Subject: Change #1 to SAE/USCAR-49, Revision 1

This letter describes a change to the USCAR-49 specification. Comments and questions can be sent to [EWCAP@uscar.org](mailto:EWCAP@uscar.org).

Current Figure 3B.

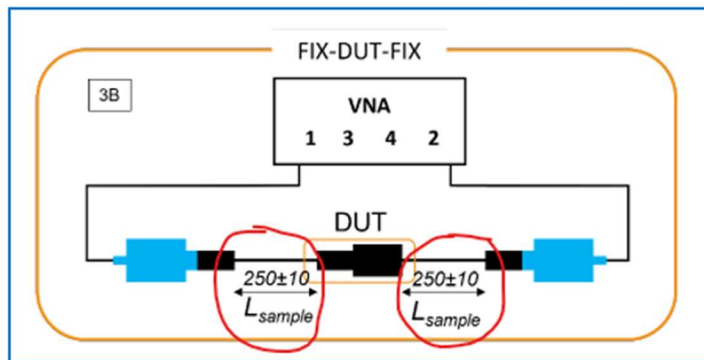
In USCAR-49 Section 4.2.3, the tolerances on the individual cable lengths in “Figure 3 – Structures for de-embedding in-line connectors” where the “FIX-DUT-FIX” cable lengths are  $250 \pm 10$ mm. This differs from the cable length tolerance as shown in Figure 4 - Structures for de-embedding PCB headers” where the “FIX-DUT-FIX” cable is  $250 \pm 5$ mm. This leads to potential cable length variation during validation. The increased tolerance of  $\pm 10$ mm could also cause a scenario where 0mm of cable is included in the de-embedded S-Parameter measurements.

Update Figure 3B, “FIX-DUT-FIX”, to reflect a  $\pm 5$ mm tolerance for each cable length.
